SIOAC-ESL (DDESE-KO/14 Jul 99) (385[A]) 1st End
SUBJECT: Explosives Safety Submission, Ordnance and Explosives (OE) Removal
at the Open Burning Grounds, Seneca Army Depot Activity, July 1998

**Ordnance And Explosives Removal
at the Open Burning Grounds,
Seneca Army Depot Activity,
Romulus, New York**

**Prepared by
US ARMY CORPS OF ENGINEERS
Engineering and Support Center, Huntsville**

**SITE MAP 3
Q-D ARCS FOR MAGAZINE
AND PLANNED DETONATION**

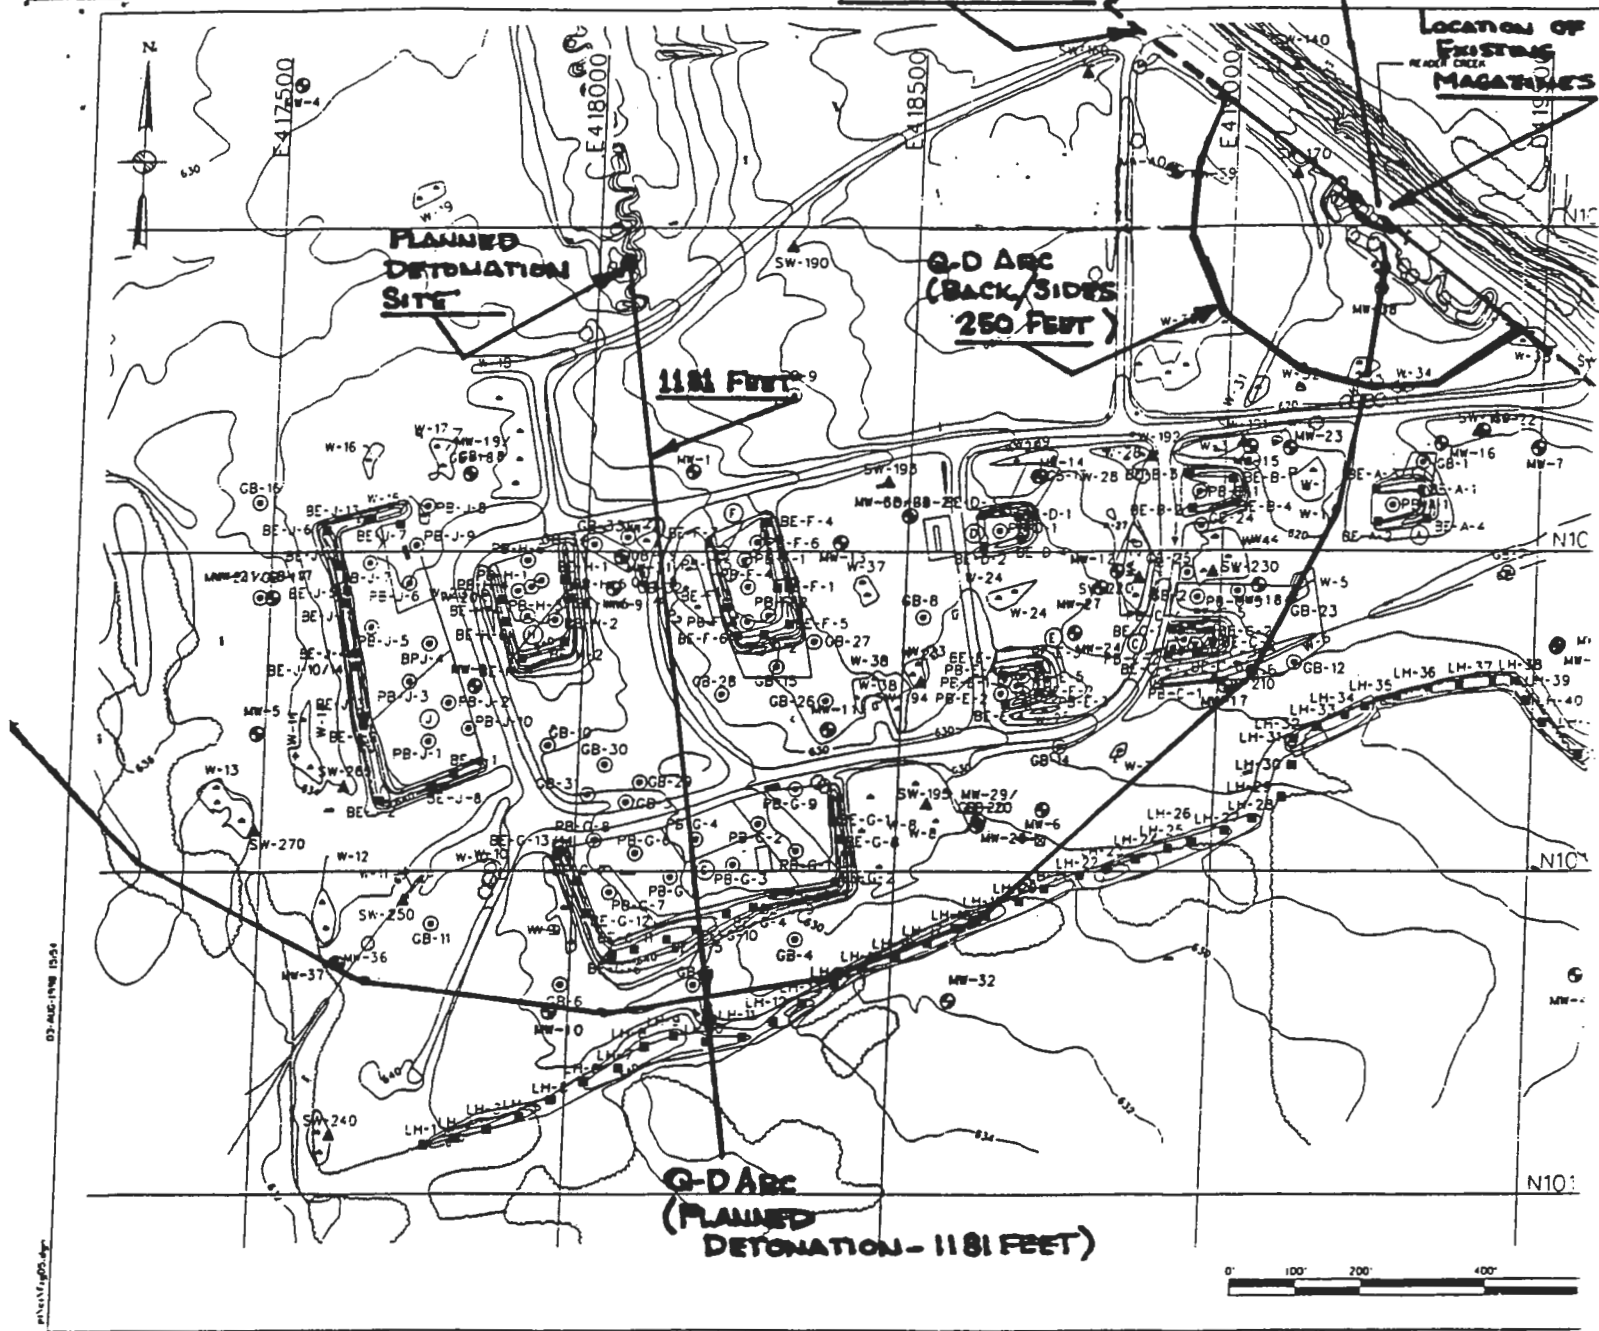
8. Site Map 3. Revise to show the Q-D's to the correct scale. {Done. Was faxed 9 Jun}
9. Site Map 4. Recommended showing a 400 foot Q-D rectangle around the entire site in order to clean up this map and make it easier to demonstrate the 400 foot sifter clearance. {Initially agreed but then rethought the issue. The reason one circle around the entire site was not shown is that we don't want to indicate that we plan to have the entire site shut down while the sifter is in operation within one corner. Later in the project, EODT will be geophysically mapping the already stripped areas for deeper anomalies. They will be able to do this and still maintain the 1181 and 400 foot Q-D's, in many instances. We don't wish to preclude this additional productivity if we don't have to. As such, the map will stay the same. All need to understand that the drawing is meant to demonstrate that the sifter will be mobile and will operate at different areas of the site at different times (as opposed to the original idea of using an immobile sifter that is setup for the duration in one spot). The multiple Q-D arcs are meant to demonstrate that, regardless of the location of the sifter, at any given time the 400 foot Q-D distance will be maintained. No action required}.

5. Site map 3: Are there any other operations going on within this new arc? ***{NO}***
6. Site map 4: Disagree with your response. The map needs to show the maximum area that could be covered by a QD arc, so DDESB can approve the "worst case". I can easily explain that the arc will be changing daily. That arc could be added to site map 3 instead of changing site map 4. ***{SITE MAP NO. 4 WAS REVISED TO SHOW THE 400 FOOT Q-D ARC AROUND THE ENTIRE SITE. THIS IS IN ORDER TO REPRESENT THE WORST CASE, AS REQUESTED.}***

SITE MAP 4
SIFTER LOCATIONS AND Q-D
ARCS

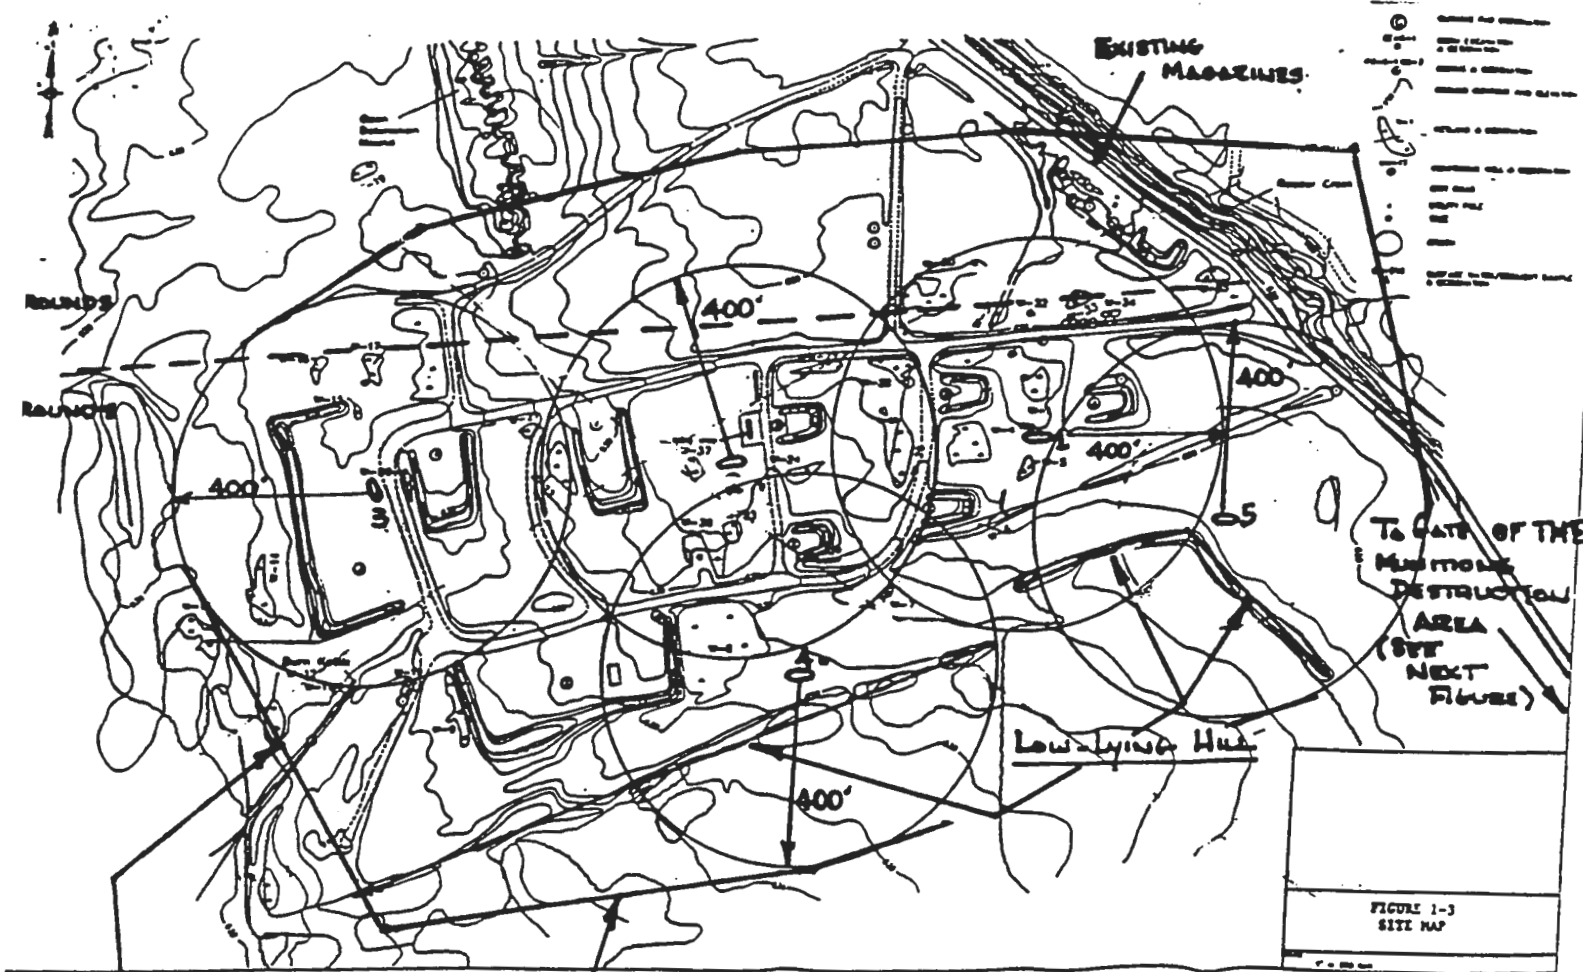
{Ms. Gallagher disagreed with this response to Number 9, so the correct Q-D arc was shown on the map as stated in the responses to her second round of comments}
